RE: Ogilvy River Farm Pit (Permit No. M-2024-006)
Adequacy Review #1

Ogilvy River Farm, LLC has received the Division's Adequacy Review #1 letter dated April 26, 2024. Below are the comments and the corresponding responses that we have provided to address the comments.

Mining Plan

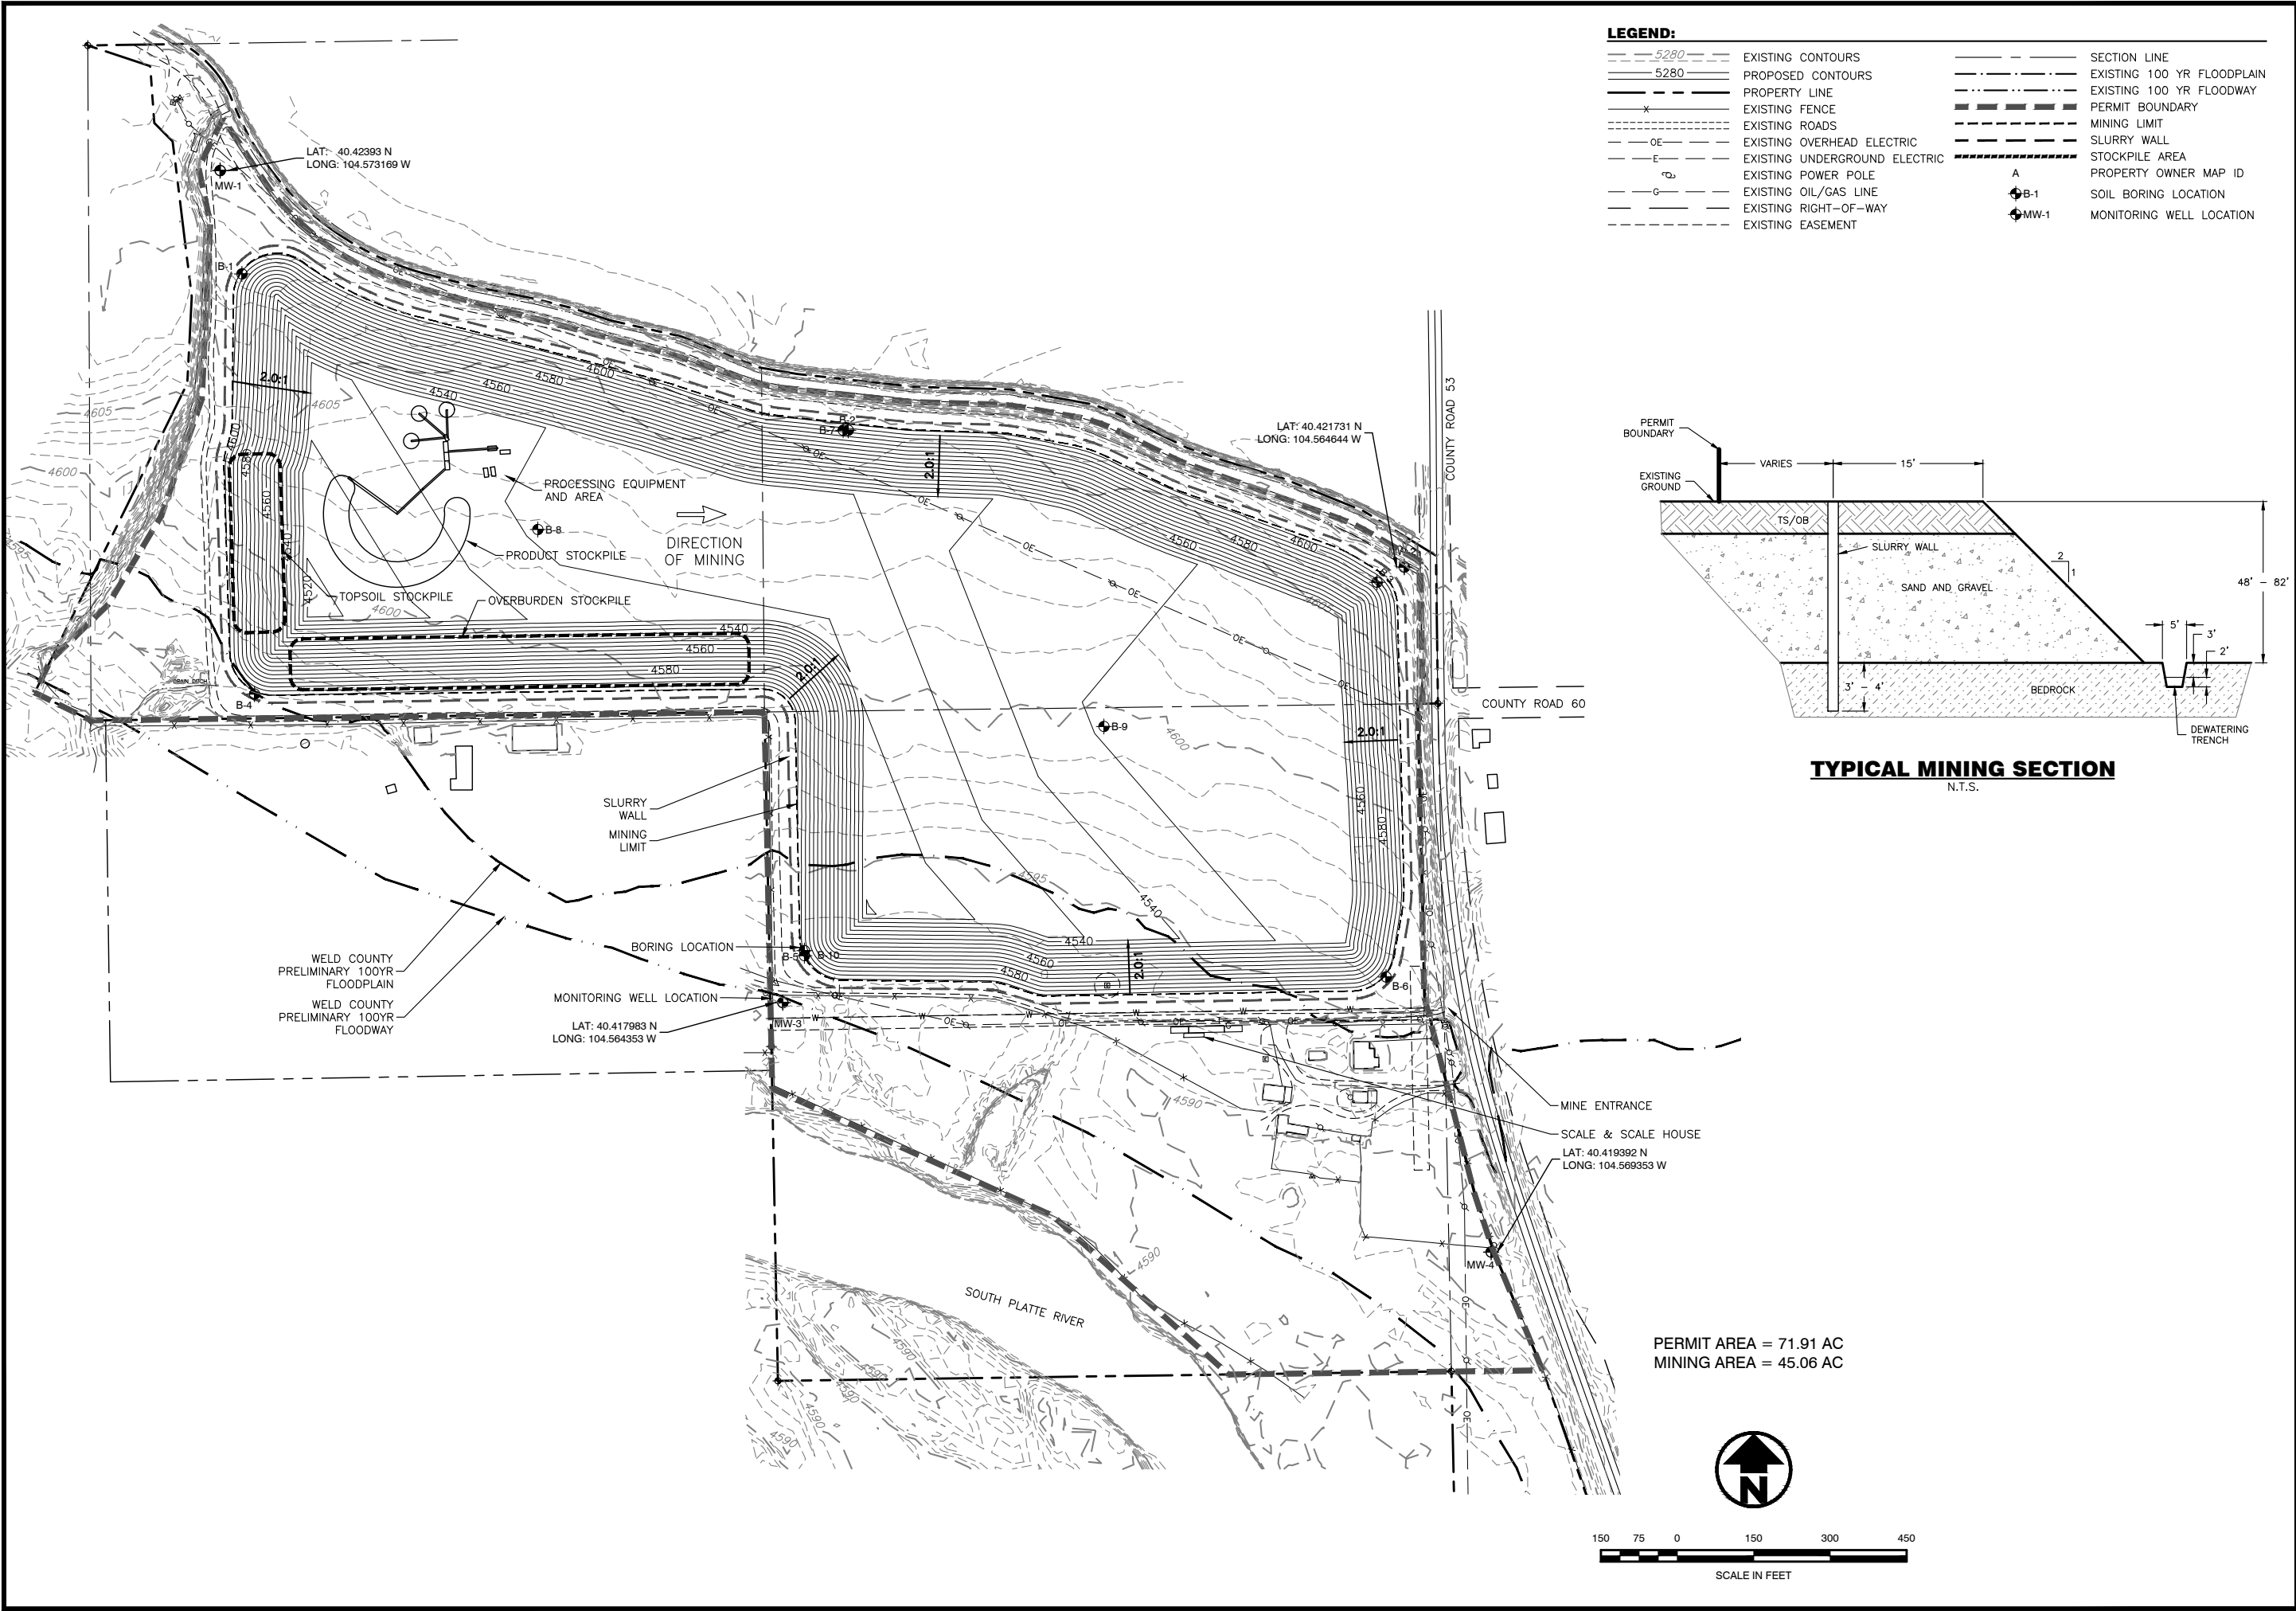
1. The chart on page D1 shows that 45.06 acres will be mined, 2.34 acres as roads the remaining 24.51 acres as disturbed. Can you describe how the 24.51 acres will be disturbed? The type of disturbance in this area needs to be described in clear detail because of its proximity to the South Platte River.

Response: *The chart on page D1 has been updated to show where disturbed acres are located. The disturbed areas will be adjacent to the mining slopes, and the area where the scale/scale house will be located adjacent to the access road. The majority of the area south of the existing road will not be disturbed adjacent to the South Platte River.*

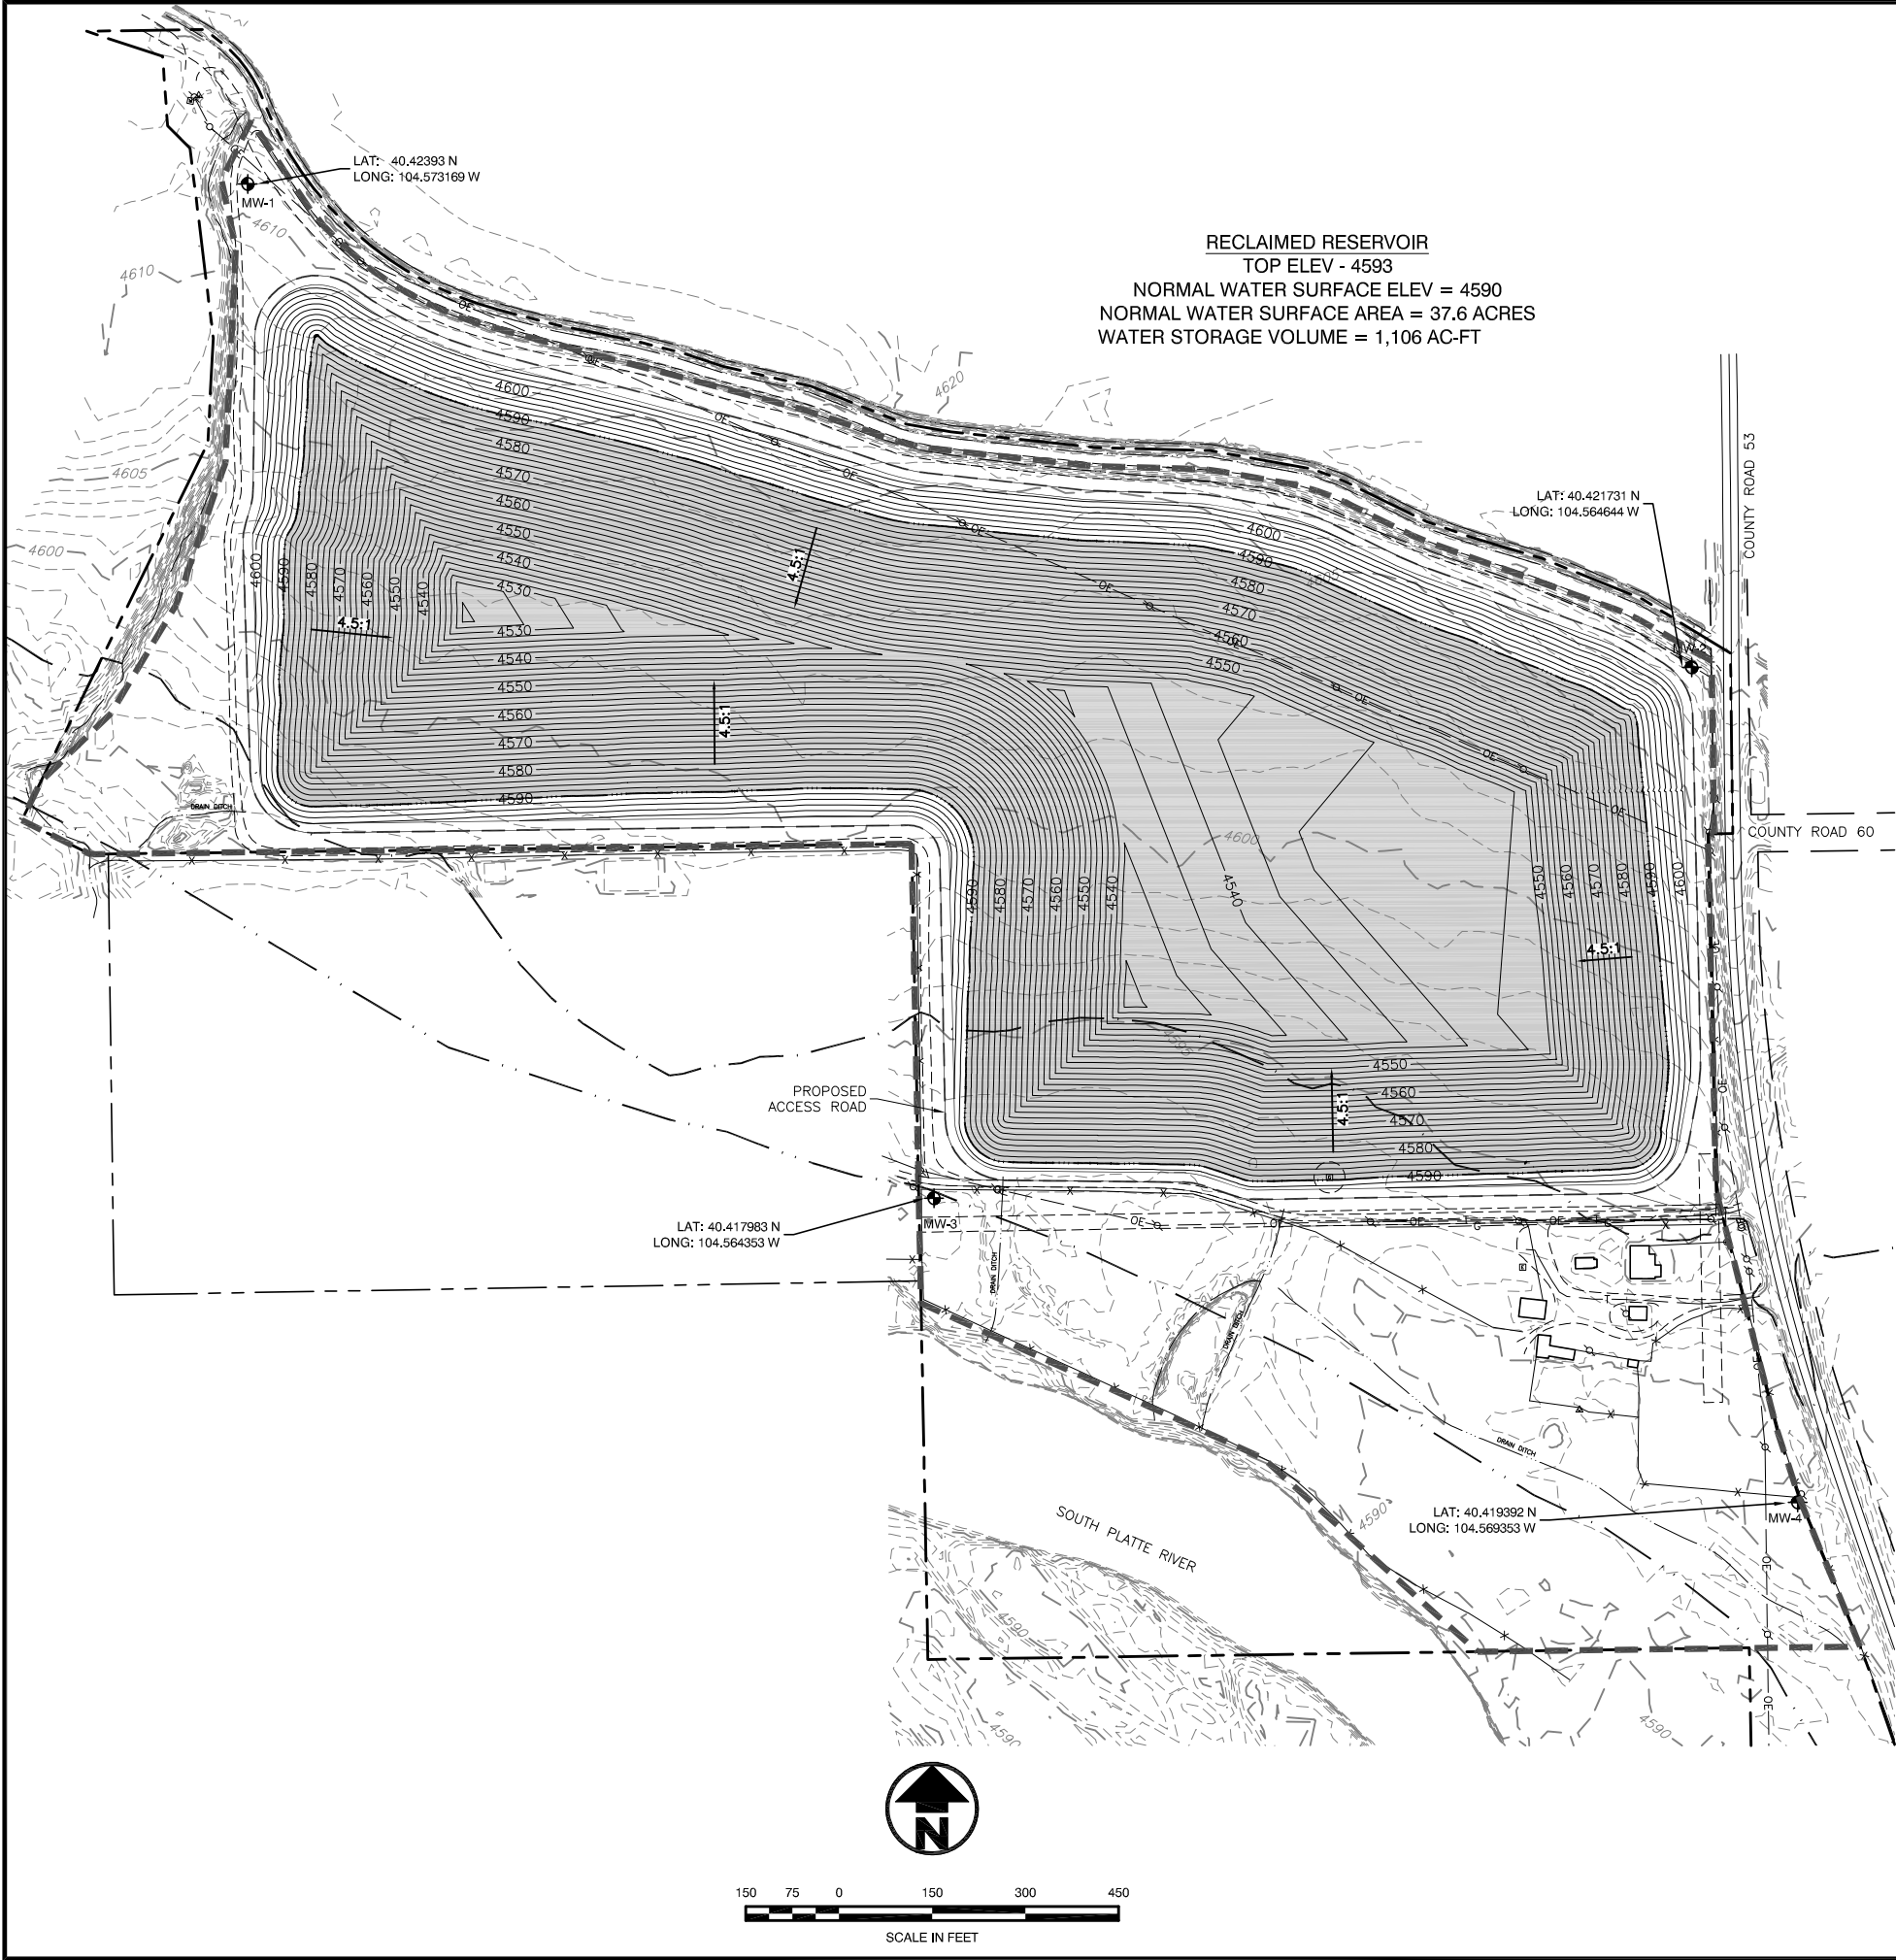
3. The area south of the access road is shown as being topsoiled and seeded, although no mine related disturbance is proposed in this area. Please clarify why this area is being topsoiled and seeded.

4. The area south of the access road is shown as being completely covered with topsoil and seeded. Exhibit C1 shows that a large portion of the area contains buildings, paddocks, driveways, and easements. Are all these areas intended to be topsoiled also?

Response: *The acreage has been updated to show where disturbed acres are located and the majority of the area south of the existing road will not be disturbed adjacent to the South Platte River. Exhibit F1 – Reclamation Plan Map and Exhibit F2 – Reclamation Plan Seeding Map have been updated to reflect the updated area to be topsoiled and seeded. The Final Land Use table in Exhibit E has also been updated to reflect this change.*

Response: *The acreage has been updated to show where disturbed acres are located and the majority of the area south of the existing road will not be disturbed. The area adjacent to the existing paddocks, driveway, and easements will not be topsoiled and seeded. Exhibit F1 – Reclamation Plan Map and Exhibit F2 – Reclamation Plan Seeding Map have been updated to reflect the updated area to be topsoiled and seeded.*

Project Ogilvy River Farm Pit
Slope Stability - Case SS-2 Mining Slope - Static

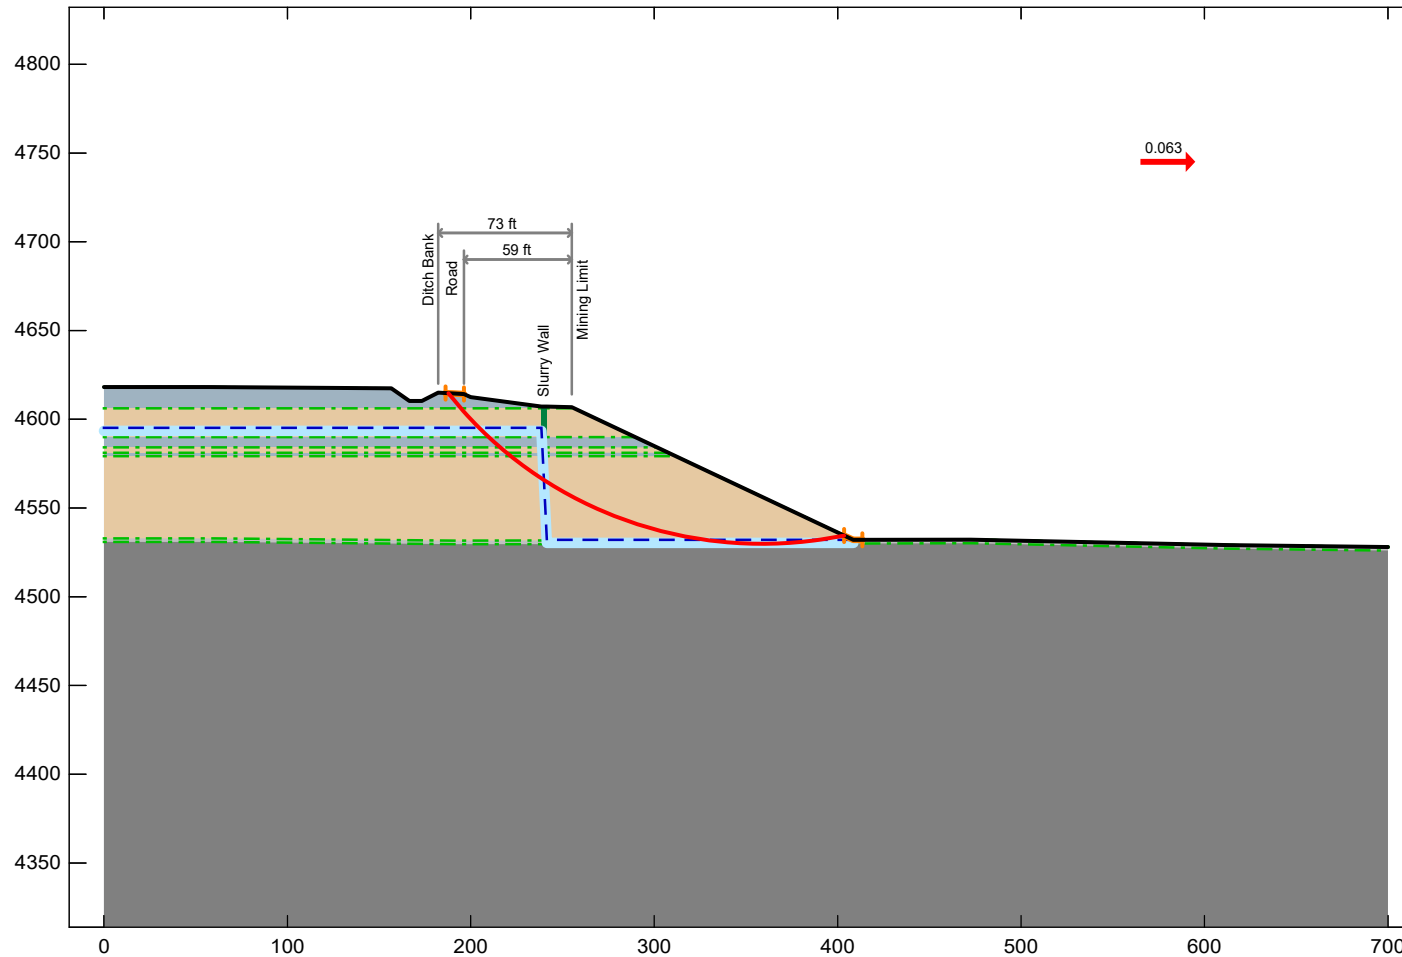
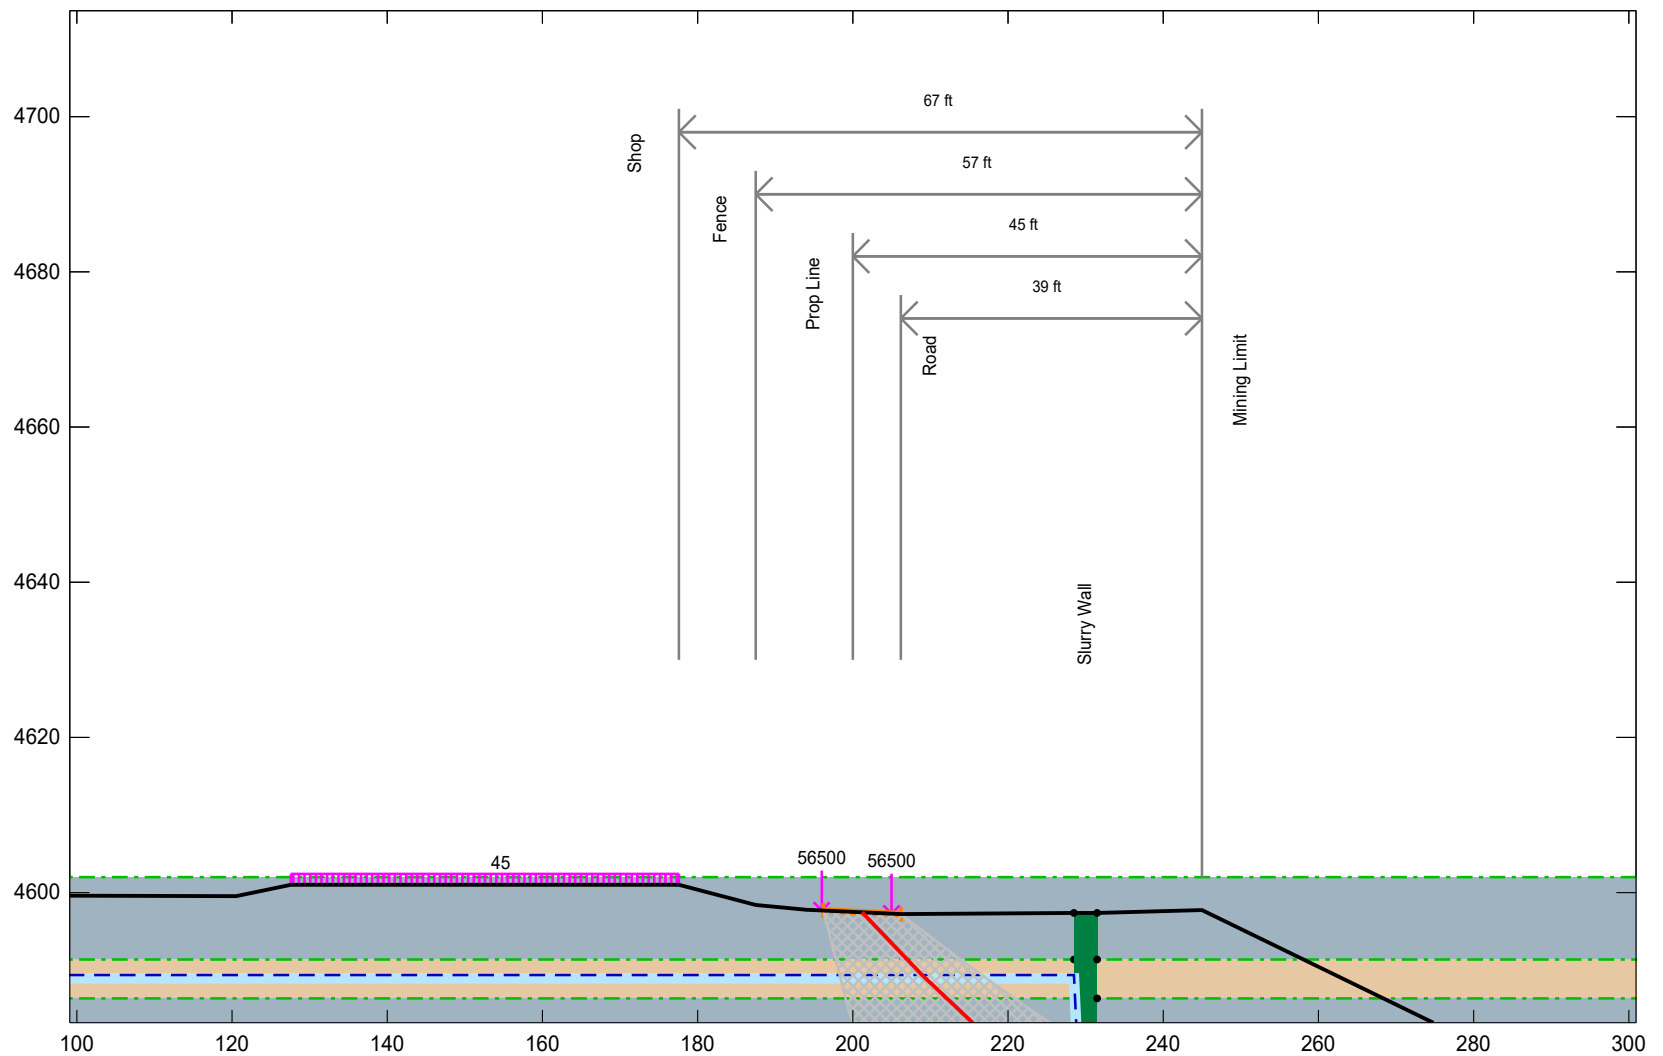
17. A setback of 59 feet from the mining limit to the gravel road was demonstrated as meeting the MLRB requirements for Case SS-2. Can you clarify the distance from the mining limit to the irrigation canal?

Response: Yes, the distance from the mining limit to the irrigation canal is 73 feet.
